**SUB: Modification on Fuel Pump of HHP Loco.****Ref:** Railway Board Letter No. 2022/M(L)/466/23 dated 04.01.2023

Revised Mod sheet no. MP.MOD.EM.02.08.15 (Rev-01) is enclosed herewith for kind information and implementation.

**Document No.MP.MOD.EM.02.08.15 (Rev-01) 18-05-2023**

**Provision of standby inverter and shim (in existing inverter fitted with FPM) on fuel pump motors of HHP Locomotives**

Fig.1 Location of fitment of inverter and selector switch

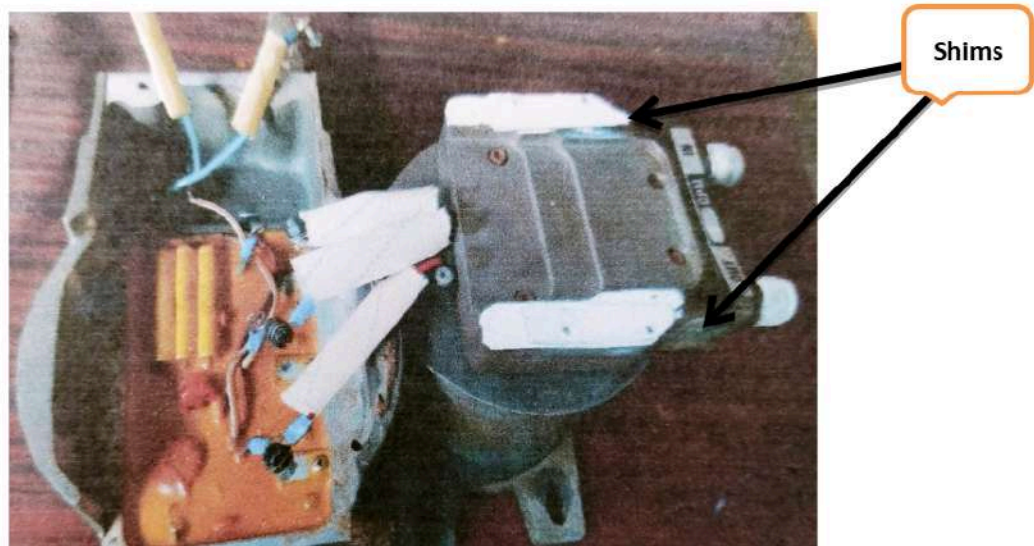
a) Provision of additional inverter to be provided at equipment rack (lube oil cooler mounting channel).Ref. Fig-1

- b) Provision of selector switch (Rotary switch 30A, 6NC-6NO interlocks) fitted to a wooden box shall be located near water tank to select existing inverter and standby inverter. Refer fig-1 & fig-4.
- c) Provision for maintaining gap between motor and inverter by providing 5mm thick aluminum shims (2no's) with heat sink compound to enhance the cooling efficiency of existing inverter fitted with Fuel Pump Motor (*Which is beyond warranty*) as shown in fig.2.
